## REQUEST FOR INFORMATION

RFI NUMBER	<b>NL-RFI-042</b>
ISSUE DATE (YY/MM/DD)	April 13, 2011
PRIORITY	H <input checked="" type="checkbox"/> X <input type="checkbox"/> M <input type="checkbox"/> L <input type="checkbox"/>
REQ'D RESPONSE DATE	April 15, 2011

### Hope Bay Mining Project

Subject:	Windy Camp Temporary Diversion Berm	Project Zone/Area:	Windy Camp
Company:	Nuna Logistics Ltd. (Nuna)	Station/Location:	Windy Camp
Attention:	Mark Valeriot / Doug Fielding / Jerry Graham	Discipline:	Civil

SECTION A-A'

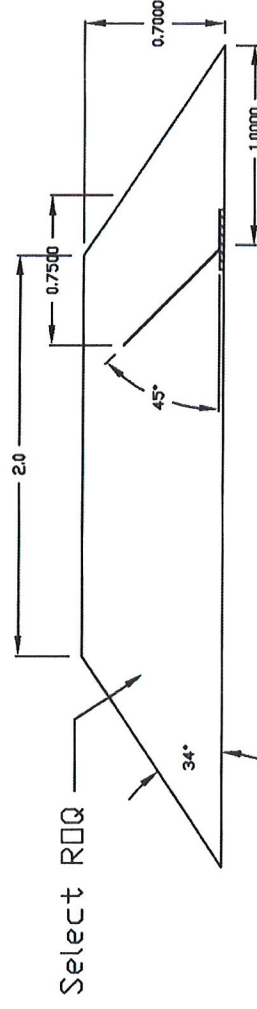
Nuna has reviewed the SRK IFC package during work plan preparation for the Windy Camp Temporary Diversion Berm. SRK is requested to confirm that the bentonite layer depth at the base of the GCL liner shall be sufficient to cover the ground.

Construction to the current design would require multiple handling of ROQ materials to accommodate GCL liner installation. Construction equipment access from the surrounding tundra would be required for truck turnarounds and excavator access.

Nuna proposes the following design revisions as shown on the attached sketch:

- Reverse GCL Liner slope to follow the east Berm shoulder.
- Relocate the GCL liner from the Berm centerline to a minimum distance from the upstream (east) bank. Nuna proposes a minimum ROQ cover of 0.75 meters. SRK is requested to provide the minimum distance required for ROQ cover.

- 1) Yes - please reverse the orientation of the liner. This is an error on the IFC.
- 2) Yes - a Minimum 0.75 m cover is acceptable. This will still allow the GCL to be confined in order to function properly.

- 1) No - the GCL cannot be draped on the upstream face of the berm. GCL needs to be confined in order to function.
- 2) No - 5/8 clear material [fines crushing reject material] cannot be used as construction material instead of select ROQ. The select ROQ must be compacted.
